# KB2LJJ

### Modifications for the Kenwood TS-930

## TS-930S CW Pitch Tone Shift

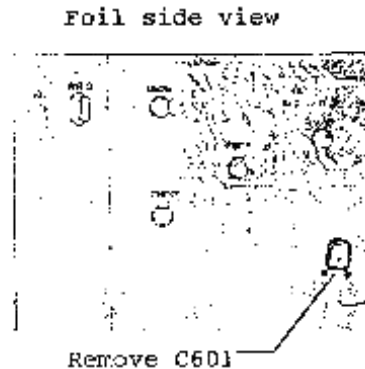
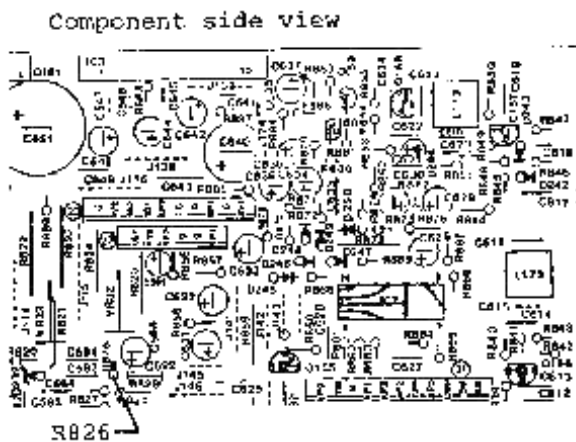
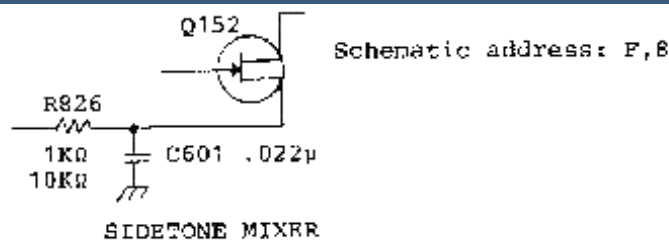
On the Signal unit (X57-1000-XX) change R826 from a 1 K ohm resistor to a 10 K ohm resistor and remove C601, a .022uF capacitor from the foil side of the circuit board.

## TS-930S 15 Meter Internal Beat Tone

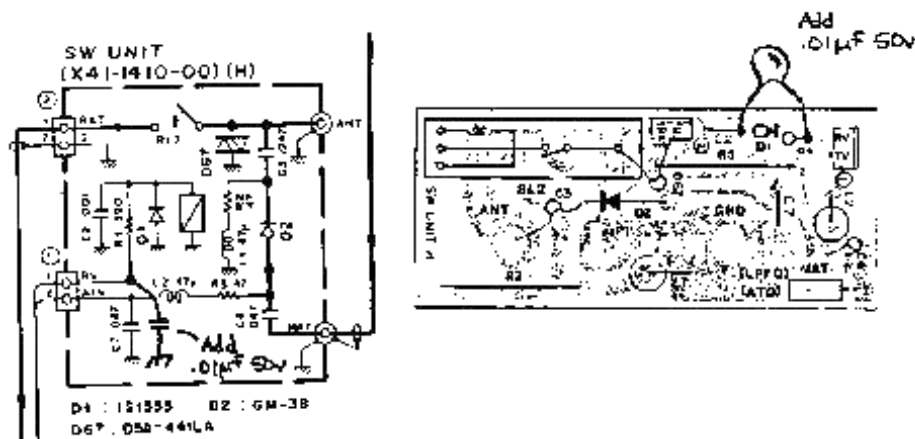
Some users have reported an internal beat tone that appears every 10 KHz, when operating in the range of 20-21.5 MHz. Apparently the RV terminal switch unit H is being affected by the 1st loop of the PLL unit. The cure is relatively simple. Add a .01 μF 50V disc ceramic capacitor on the RV line of switch unit H as shown below.

## TS-930S RF Feedback

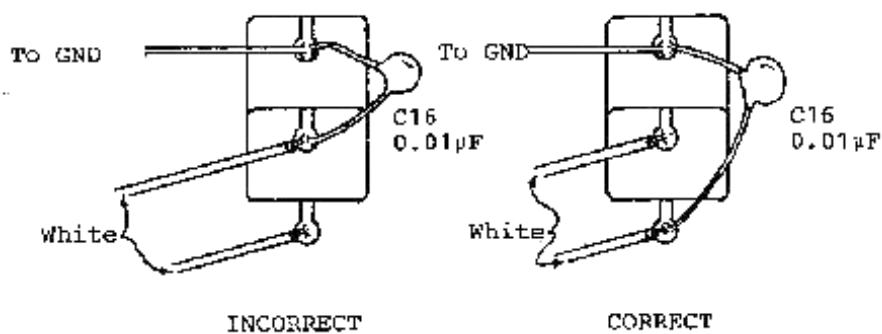
For reports of RF feedback from the external speaker, especially when using a vertical antenna, or a linear amplifier, check for correct installation of capacitor C16 on the EXT SPKR jack.

C16 should go from ground to the white wire on the opposite side of the jack. Some units have the capacitor soldered to the middle terminal in error!

Figure 1

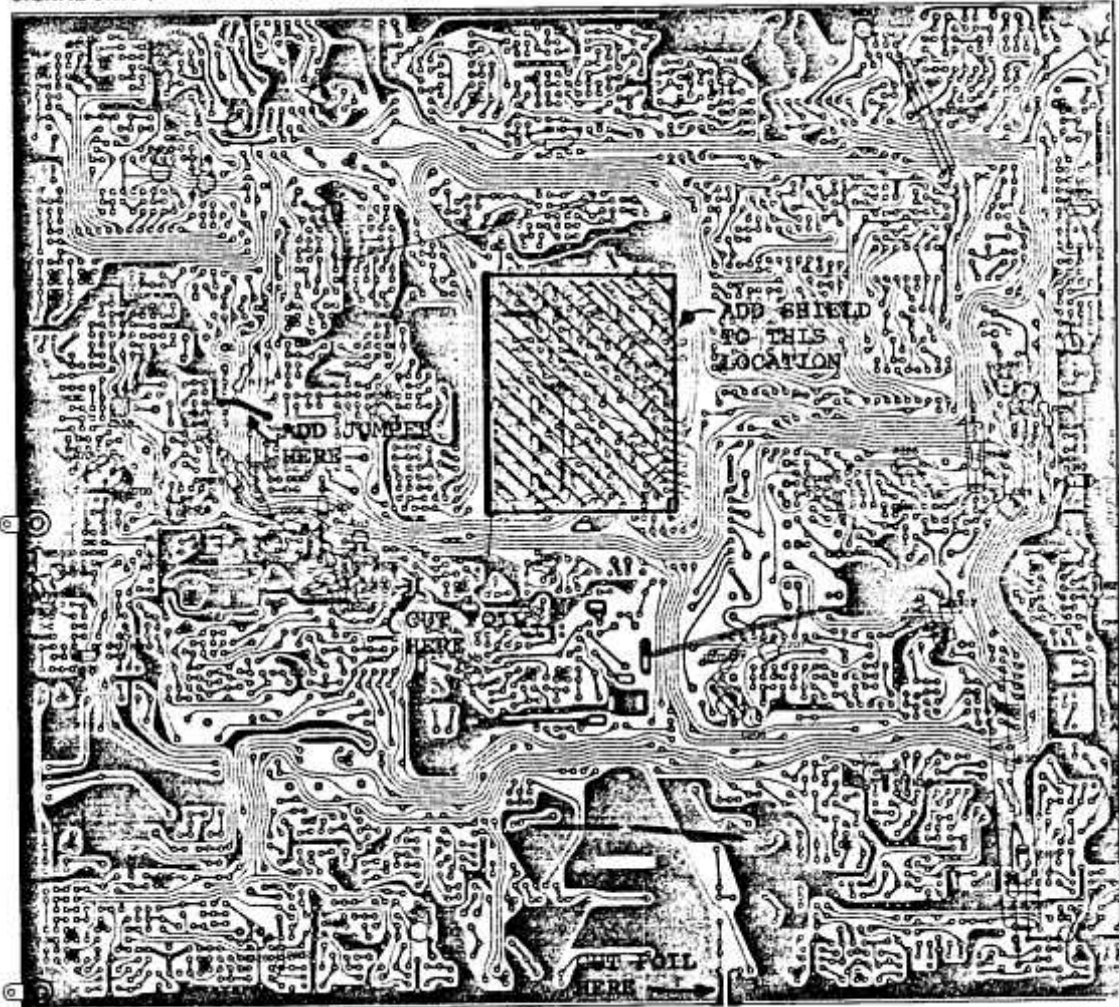
Install the shield plate as shown in figure 1. Cut the circuit foil and add the jumper wire as shown.

Change the following components:

Change R635 to 8.2 Kohm

Change R501 to 22 Kohm

Change C469 to 3 pF

Change C473 to .5 pF

Change C476 to 1 pF

Figure 3

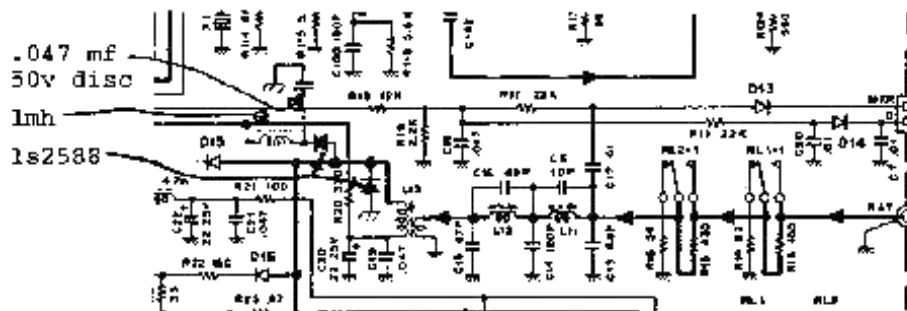
Figure 3 show a circuit that is capable of withstanding antenna input levels of up to 50 Watts. Use this on units that may be subject to high levels of RF. (This is an optional change that may not be done in-warranty.)

## TS-930S Feedback into MIC CRT

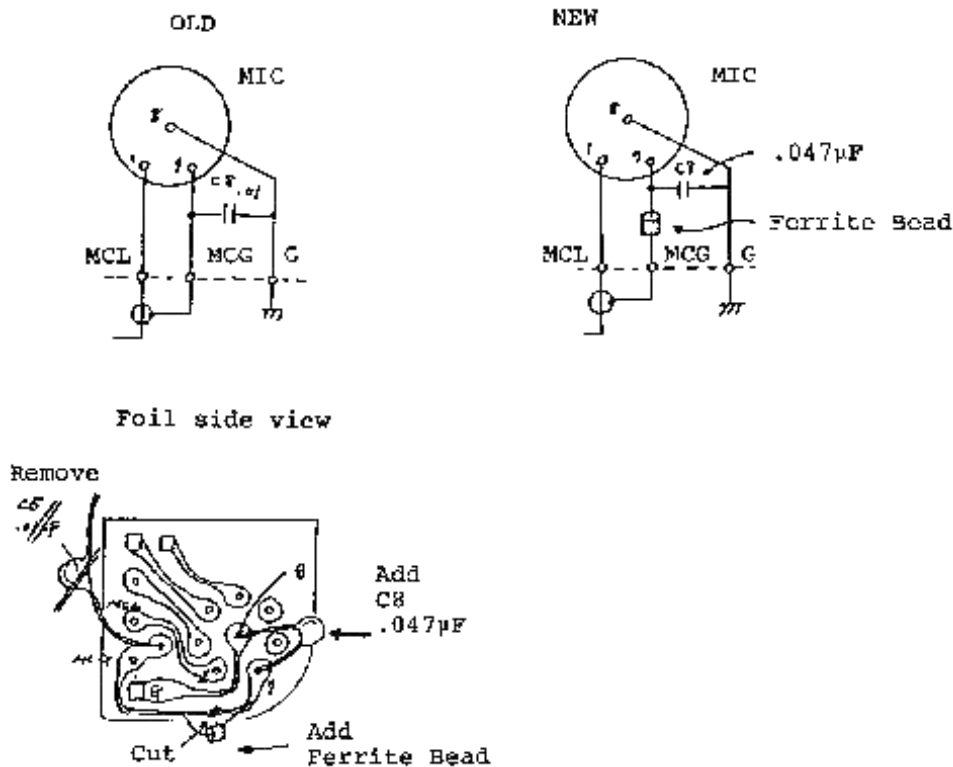
Some users may report RF feedback to the MIC at low frequencies, for example: 3.5 MHz.

Make the following changes to SW unit (J) (X41-1410-00):

## TS-930S ALC level drift 28 MHz CW

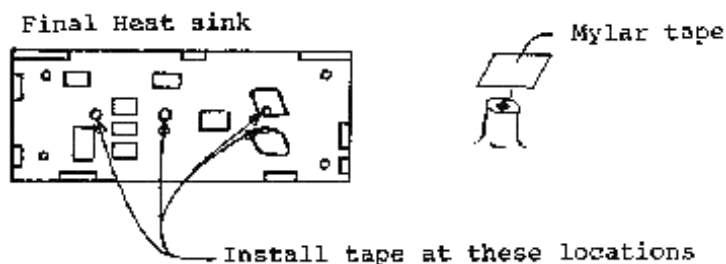
Some users have reported that the ALC meter indication occasionally jumps during long key down periods on the 28 MHz portion of the bands. The symptom may be caused by the ground foil of the Final unit (X56-1430-00) coming in contact with one or more of the projections on the final heat sink, due to expansion when the temperature rises.

Apply Mylar insulating tape to the projections on the heat sink, to prevent reoccurrence of this symptom. See figure below.

## TS-930S Power Supply surge protection

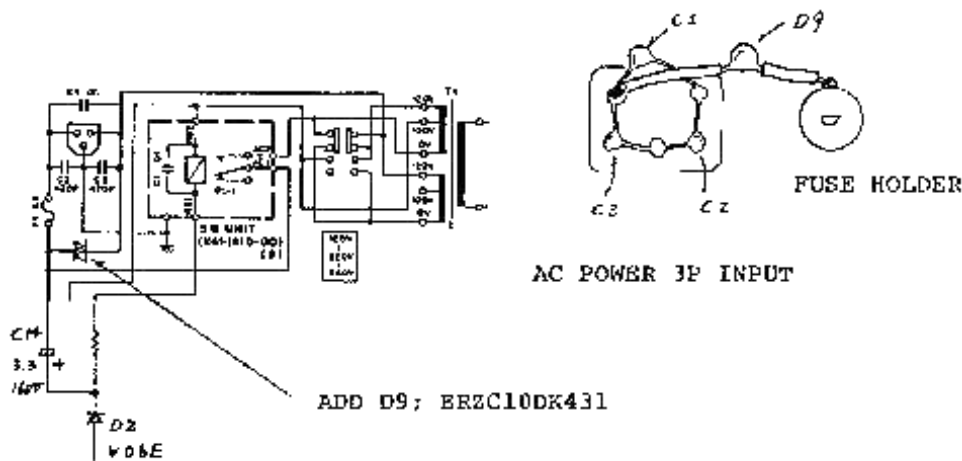
A line surge (exceeding approximately 4.5 kV) due to static electricity or nearby lighting discharge may short power relay diode, D2 (V06E), and cause electrolytic capacitor C14 (3.3  $\mu$ F) to break down. This results in relay chatter and the relay contacts may finally weld.

Addition of the surge absorber to the primary power supply input circuit, as shown below, should help avoid this type of failure.

## TS-930S Noisy Power Supply Fan

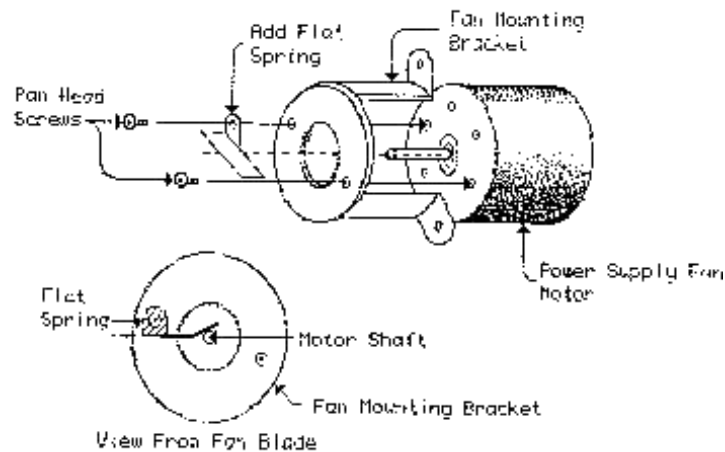
Some users of the TS-930S have reported that the Power Supply Fan motor makes excessive noise. This fan motor was originally designed to drive a pulley system. By adding a small amount of lateral tension to the motor shaft this noise is reduced or eliminated. The procedure listed below should correct any tendency of this motor to make noise.

Parts Required: Flat Spring Part Number: G02-0549-04

Add the Flat Spring as shown in the figures below.

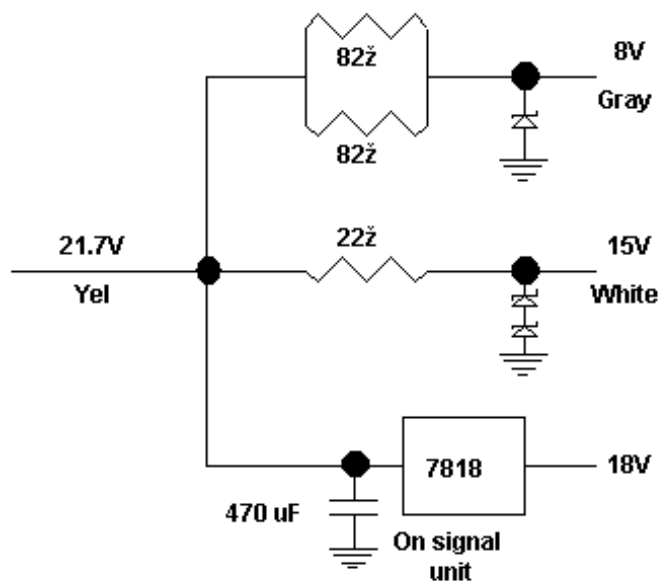
The power supply uses high-wattage resistors and zener diodes in the power supply fan case to reduce the 21.7V secondary supply voltage 7.5V and 15V for the digital board (which has 5V and 12V regulators) and for the signal unit, which has an 18V regulator. The 21.7V is distributed by the yellow wires via a black terminal block between the antenna tuner and the filter unit; this block also has the switched +28.5V orange wires. The original circuit looks like this:

The main schematic diagram of the radio is wrong, it shows the 33Ω resistor that is the third supply voltage for the digital board connected to the 21.7V instead of the 28.5V line.

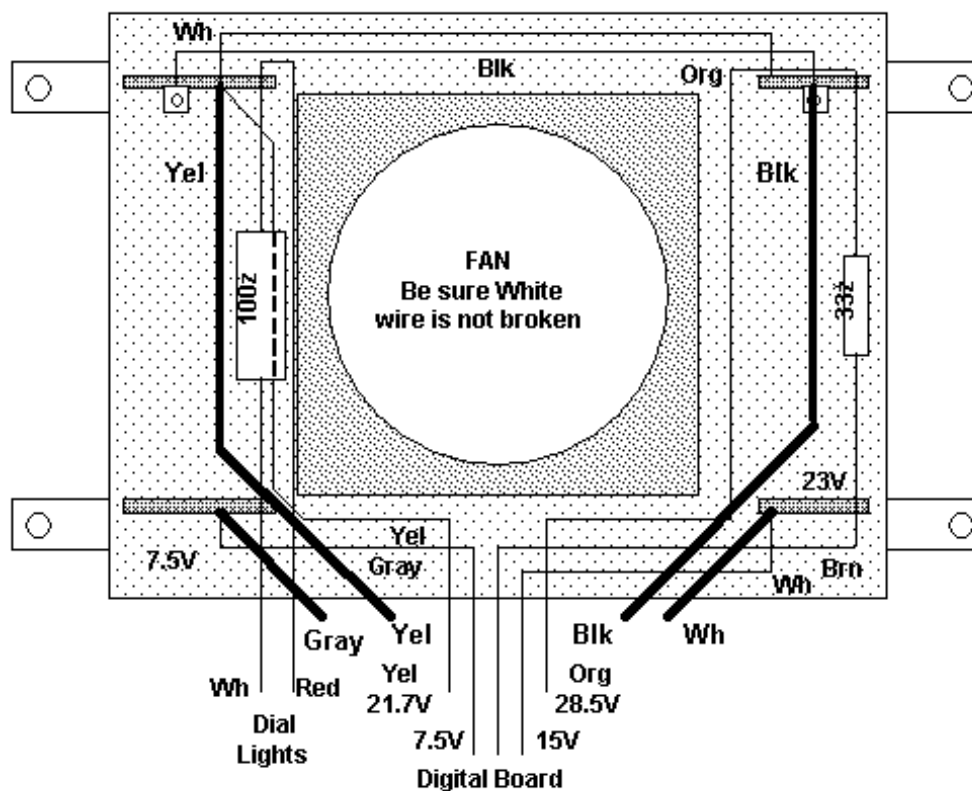
The resistors to be replaced are inside the power supply fan case. You will notice that the resistors will have lost their color coding from overheating, and the terminal strips may be somewhat charred, from overheating. Cut out the two 82 $\Omega$  resistors and their zener diode, and cut out the 22 $\Omega$  resistor and its two zener diodes. You can save these in case of trouble, but the new circuit should be more reliable.

The fan case should now look like this:
